Title		
MST6M48RXS		
Size	Document Number	Rev
A3	System Power	A
Date:	Thursday, July 15, 2010	Sheet 1 of 7

Title		
MST6M48RXS		
Size	Document Number	Rev
A3	Video & Audio	A
Date:	Thursday, July 15, 2010	Sheet 5 of 7

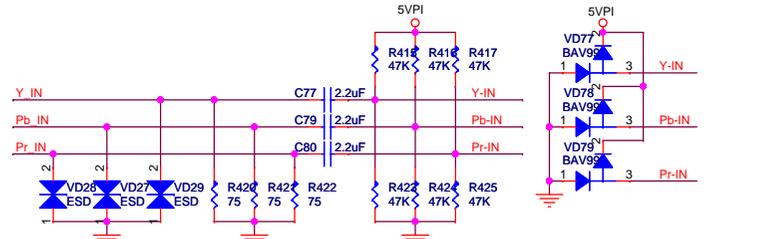
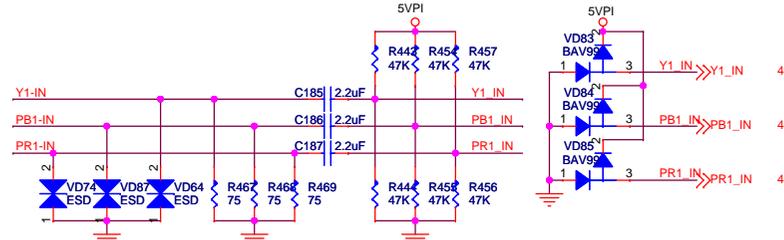
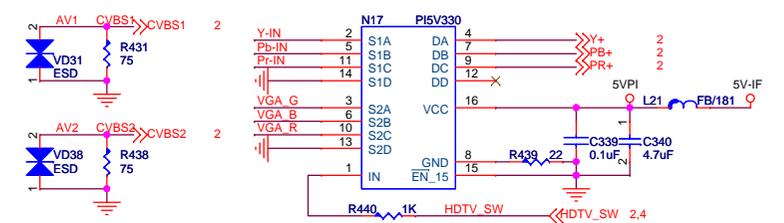
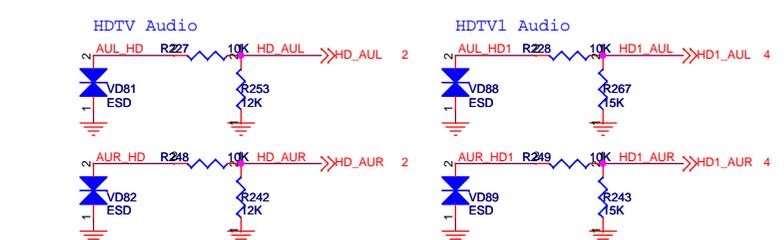
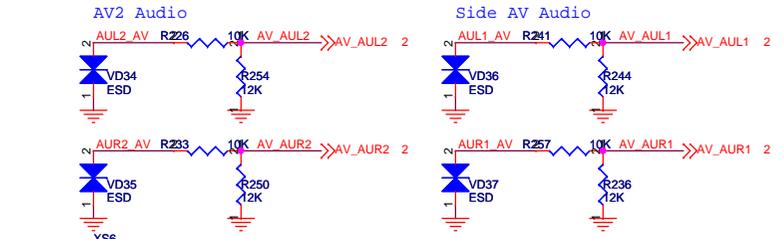
为了更改2路高清伴音不一致问题，R870 R873 R874 R875由47K改为56K

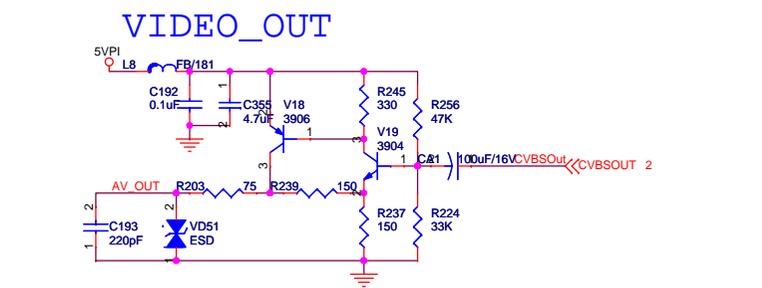
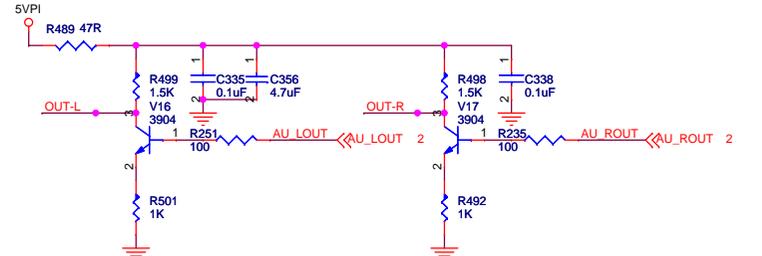
为了更改2路高清伴音不一致问题, R267 R243更改为15K
